ADDENDUM NO. 2

May 8, 2019
125334P-4A-72

RE: **CITY OF BARRE**
 KEITH AVENUE PARKING LOT IMPROVEMENTS (PART A)
 PEARL STREET PEDESTRIAN WAY IMPROVEMENTS (PART B)

CATCH BASIN DETAIL

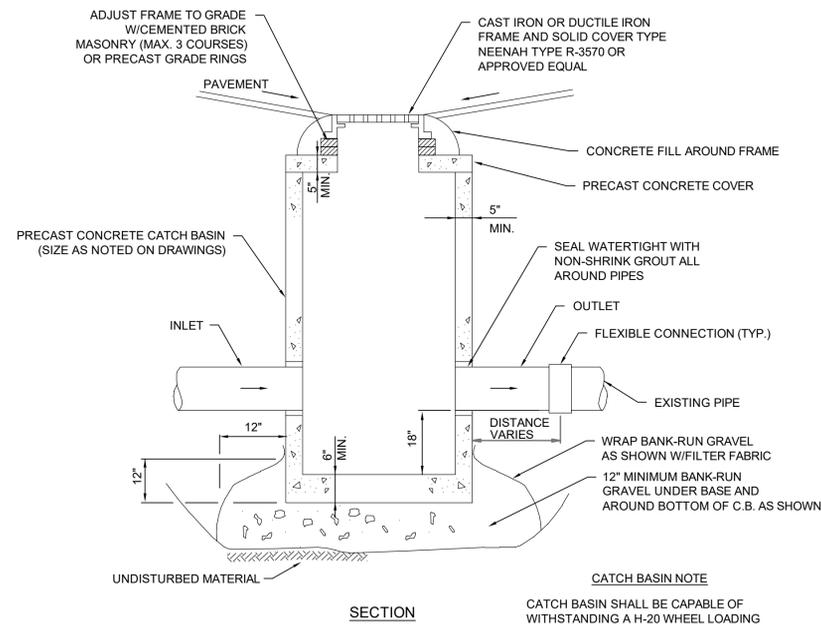
Question 3: What is the size of the pipe that catch basin #6 ties into?

Answer 3: 8-inch, Contractor to field verify.
